# Access Compliance Report

## Public Rights-of-Way

### (Curb Ramps)

Intersection ID: 2850	Main Street: BEAUVISTA_DR	Cross Street: PECAN_COVE_LN	Location: NE
ADA ID: 382F4127C41B	Ramp Type: PerpDiag	Initial Pass/Fail: Fail	Overall Compliance: No
Severity Score: 46.25			
Codes/Mitigation Info/Possible Solution		Field Measurements/Component Compliance

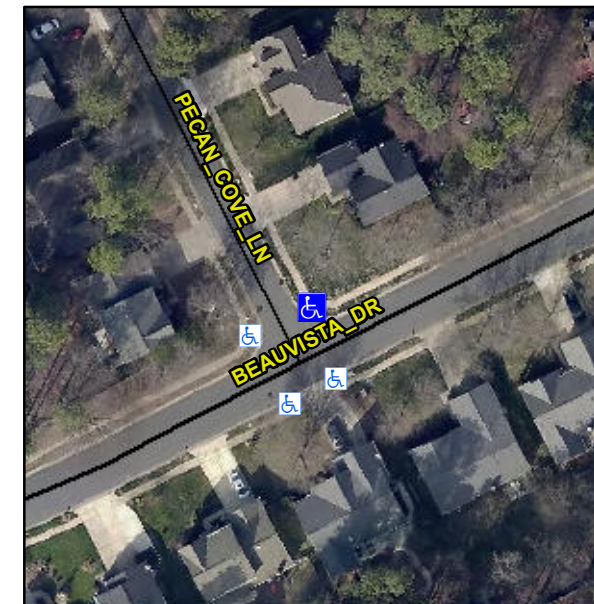
**Not Found, R304.5.1, R304.2.2, R304.5.3**

Compliance	Description	Data	Compliance	Description	Data
N/A	Ramp Length (in)	45.0	No	Ramp Slope (%)	8.9
No	Ramp Width (in)	40.0	No	Ramp XSlope (%)	8.0
N/A	Flare Type LT	N/A	N/A	Flare Type RT	N/A
N/A	Flare Slope LT (%)	N/A	N/A	Flare Slope RT (%)	N/A
N/A	Flare Traversable LT?	N/A	N/A	Flare Traversable RT?	N/A
N/A	Landing Length (in)	N/A	N/A	DWS Provided?	N/A
N/A	Landing Width (in)	N/A	N/A	DWS Contrast?	N/A
N/A	Landing Slope (%)	N/A	N/A	DWS Length (in)	N/A
N/A	Landing X Slope (%)	N/A	N/A	DWS Full Width?	N/A
N/A	Landing Curb? (Y/N)	N/A	N/A	DWS Offset (in)	N/A
N/A	Shared Landing?	N/A			
N/A	Gutter Ponding?	N/A	N/A	Gutter Slope (%)	N/A
N/A	Gutter Lip Ht (in)	N/A	N/A	Gutter X Slope (%)	N/A
N/A	Painted X Walk1?	No	N/A	Painted X Walk2?	No
	X Walk 1 Direction	To W		X Walk 2 Direction	To S
N/A	X Walk 1 Width (in)	N/A	N/A	X Walk 2 Width (in)	N/A
	X Walk 1 Slope (%)	1.1		X Walk 2 Slope (%)	7.2
	X Walk 1 X Slope (%)	4.3		X Walk 2 X Slope (%)	2.3

**Remove & Replace Curb Ramp With Two New Directional Ramps or Equivalent.**
